**PUBLIC NOTICE REGARDING PROPOSED CHANGES TO THE AMBIENT  
MONITORING PLAN FOR THE MASSACHUSETTS WATER RESOURCES  
AUTHORITY EFFLUENT OUTFALL**

**LIST OF PROPOSED CHANGES TO MWRA'S EFFLUENT OUTFALL AMBIENT  
MONITORING PLAN**

**JULY 2010**

**Figure 1 Map of proposed water column monitoring stations,**

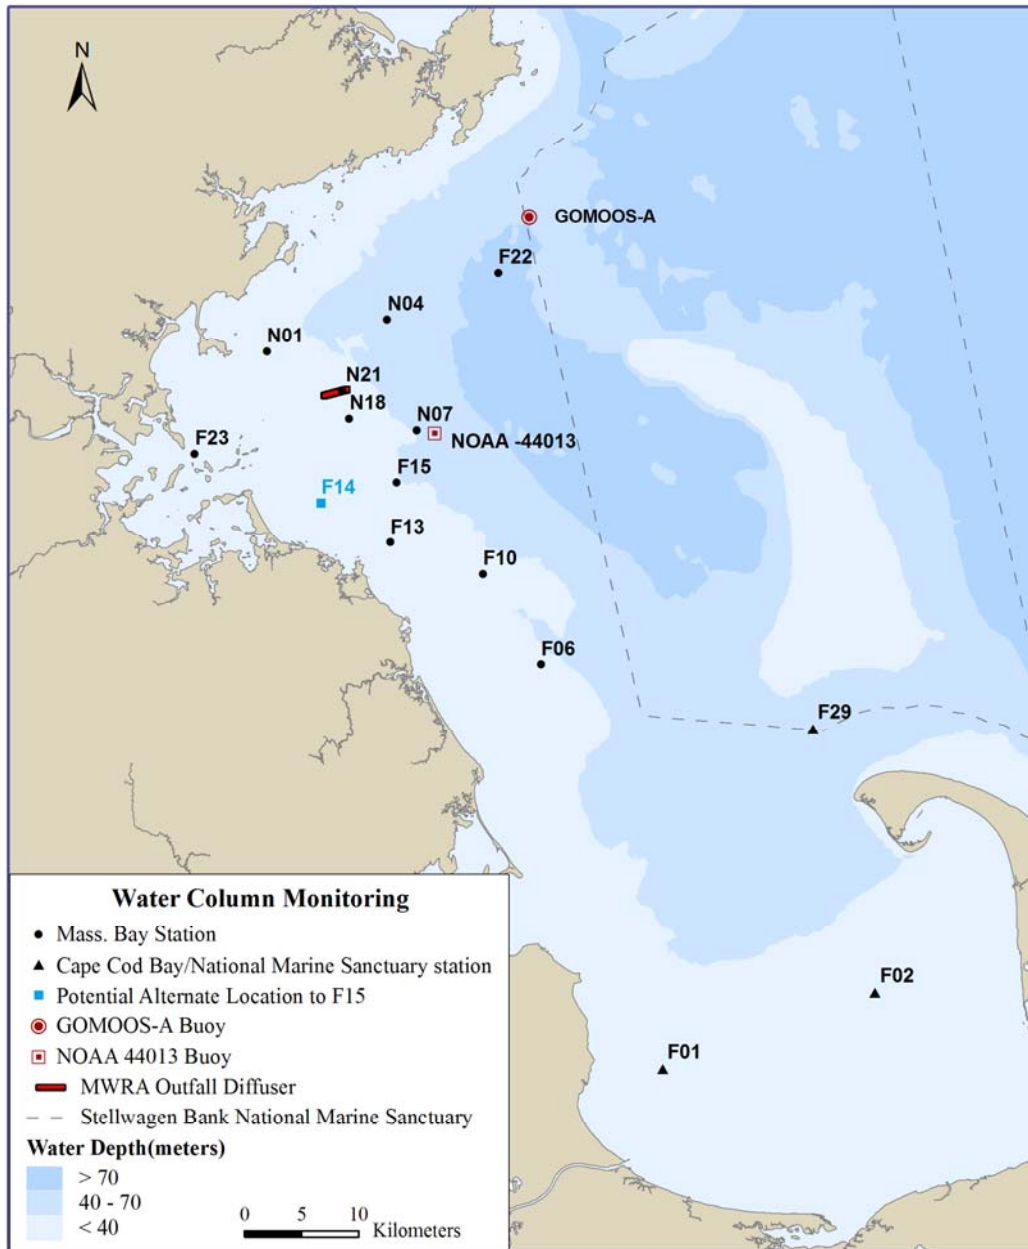
- 2.1 Reduce the total number of stations sampled from 33 to 14.** This change focuses the monitoring on the geographic area now known to have a possibility of being affected by the discharge. Reference stations are included, but most of the furthest stations are removed. ***Comment is requested for item 2.1.2 regarding whether the location of station F15 is the best location to monitor the extent of the plume south of the outfall. An alternative monitoring location for this purpose could be station F14, or a new station intermediate between F14 and F15 could be established (Figure 1).***

**2.1.1 Delete the following stations: F03, F05, F07, F12, F14, F16, F17, F18, F19, F24, F25, F26, F27, F28, F30, F31, N10, N16, N20.**

**2.1.2 Include the following stations: F06, F10, F13, F15, F22, F23, N01, N04, N07, N18, N21 (Figure 1, Table 1).**

**2.1.3 Sample three stations in Cape Cod Bay-Stellwagen Bank National Marine Sanctuary: F01, F02, F29 (Figure 1, Table 2).** Parameters will include *in situ* water quality, water column chemistry, and plankton measurements, sampled 9 times annually at two depths. Sample these stations synoptically with the nearfield and reference monitoring stations (within 48 hours).

***Comment is requested on whether station F15, station F14, or a location intermediate between the two stations is most appropriate for monitoring the southward extent of the plume.***

Figure 2 Proposed nearfield benthic sampling stations.

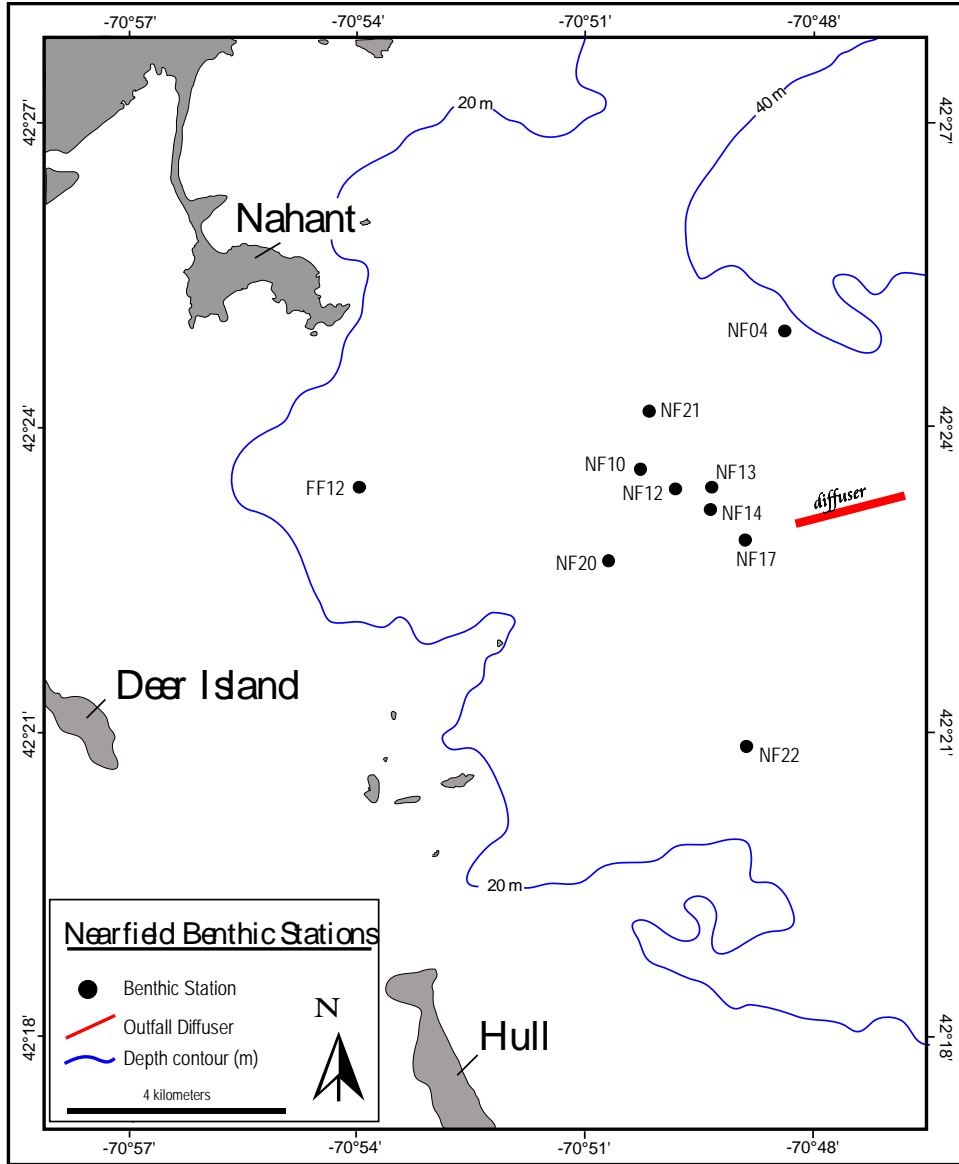
- 3.1 Reduce the number of soft-bottom community monitoring stations sampled annually from 16 or 17 (depending on if it is an even or odd year) to 13, and change the present design which samples alternating sets of stations each year to one in which a consistent group of stations is sampled every year (Figures 2 and 3).** Nearfield, reference, and Stellwagen locations are included in the soft-bottom community surveys. (Continue the cost-effective sediment profile imaging at the current 23 nearfield soft bottom stations.)

**3.1.1 Delete the following 18 benthic stations: NF02, NF05, NF07, NF08, NF09, NF15, NF16, NF18, NF19, NF23, NF24, FF05, FF06, FF07, FF10, FF11, FF13, FF14.**

**3.1.2 Community analyses at the following 13 benthic stations: NF04, NF10, NF12, NF13, NF14, NF17, NF20, NF21, NF22, FF12, FF01A, FF04, FF09**

- 3.5 Modify the chemistry sampling so that it is done at the remaining soft-bottom benthic stations (Figures 2 and 3).**
